Minutes – Appeal Committee – April 8, 2026

Item No. 3 Appeal – Variance – 689 & 691 Harstone Road (Charleswood-Tuxedo-Westwood Ward) File DAV 105345A/2026B

Title: DAV 26-105345\B – 689 Harstone Rd

Issue: For consideration of a Variance associated with the construction of two (2) single-family dwellings.

DRAWING TITLE
SITE PLAN

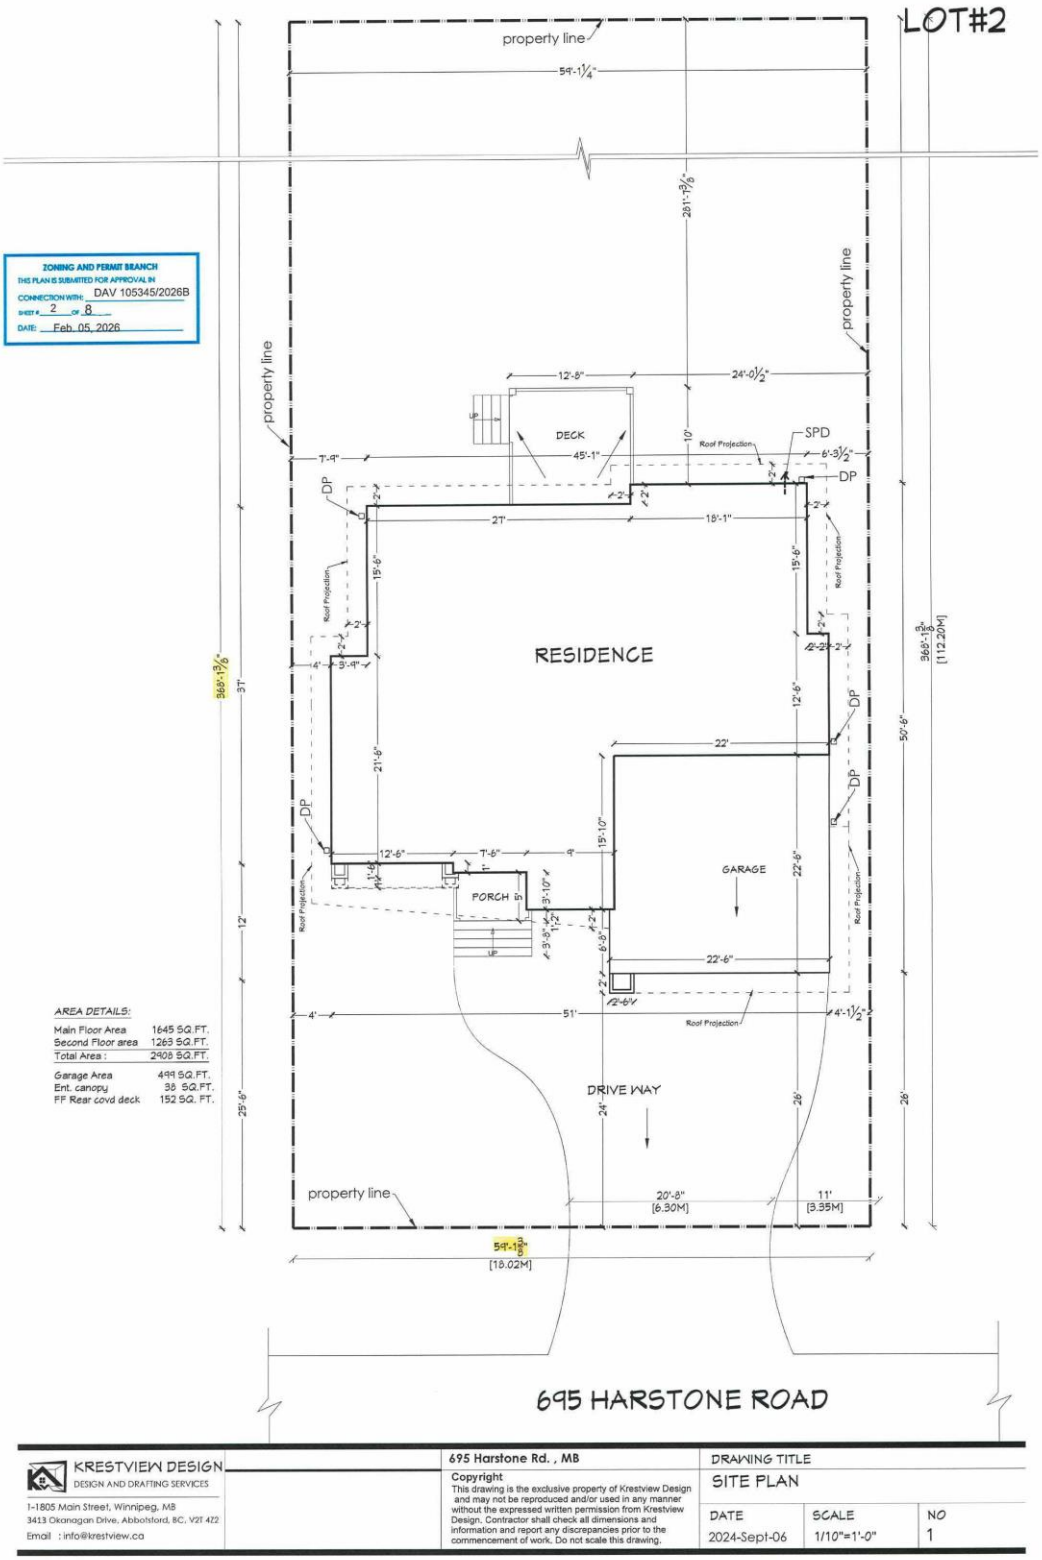
A. a front yard of 26 feet (7.92 metres) instead of 69 feet (21 metres);

B. a north side yard of 4 feet (1.22 metres) instead of 10 feet (3.04 metres);

C. a south side yard of 4 feet (1.22 metres) instead of 10 feet (3.04 metres).

1. The four foot side yards which has been a question, does not match anything on the street. This is something that would not reflect what's on the street so I would not be in favour of that.

2. The front yard setback of 25.5 feet versus the average of 69 feet is totally out of place for the neighbourhood, and if we start allowing that sort of stuff then it'll be a race to the street for the next house to see how close they can get. We have to be consistent. The average of the street is around 69 feet, that is what we should be going with.

DRAWING TITLE: SITE PLAN

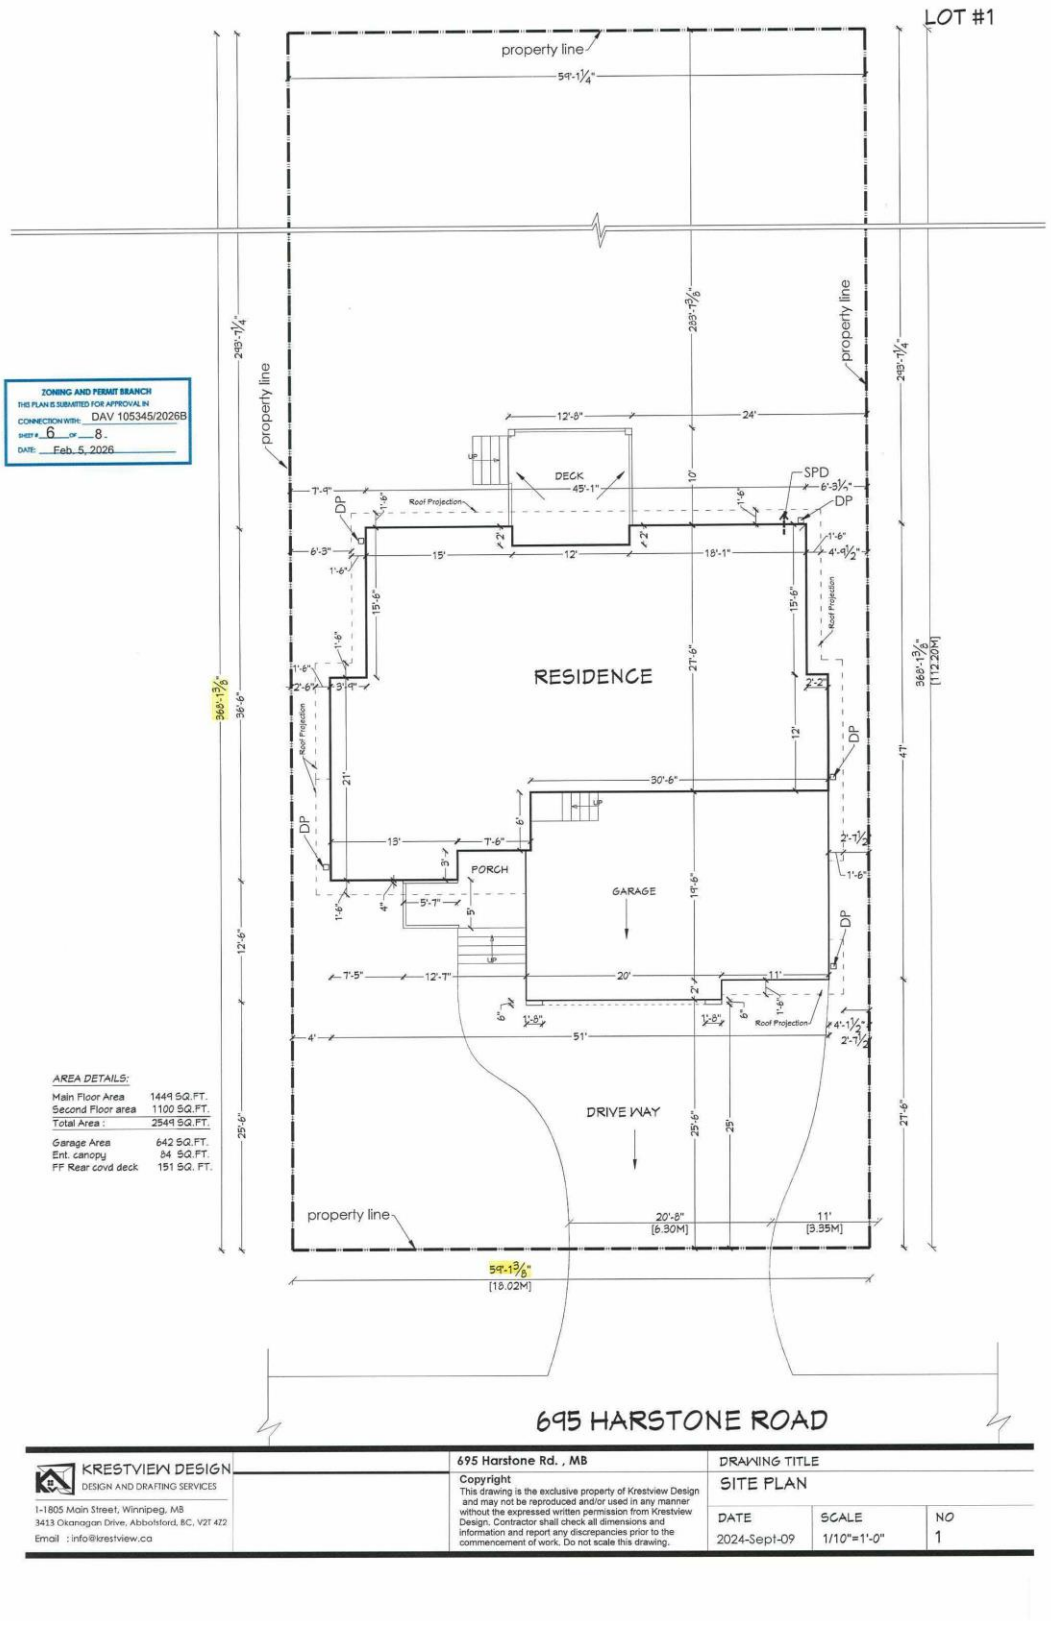
A. a front yard of 25.5 feet (7.77 metres) instead of 69 feet (21 metres);

B. a north side yard of 4 feet (1.22 metres) instead of 10 feet (3.04 metres);

C. a south side yard of 4 feet (1.22 metres) instead of 10 feet (3.04 metres);

The proposed single-family dwellings with reduced front yard setbacks are not compatible with the existing single-family dwellings on the block and given the spatial separation, will have a substantial adverse impact upon adjoining properties and the adjacent area.

Abutting properties to the north and south have front yard setbacks of 71 feet and 84.7 feet respectively.

The proposed single-family dwellings with reduced north and south side yard setbacks are not compatible with the existing single-family dwellings on the block. Since the proposed development will commence on vacant land, the Zoning By-law does not impose any hardship with a compliant design being proposed.

Each of the lots is approximately 60 feet wide. Taking into account the required 10 foot side yards, the Zoning By-law allows a 40 foot wide house. The buildable depth is 277 feet, the total buildable footprint of each lot is 11,080 square feet (277' x 40'). Given the sizable building area that is already permitted, the By-law does not impose any hardship on the applicant.
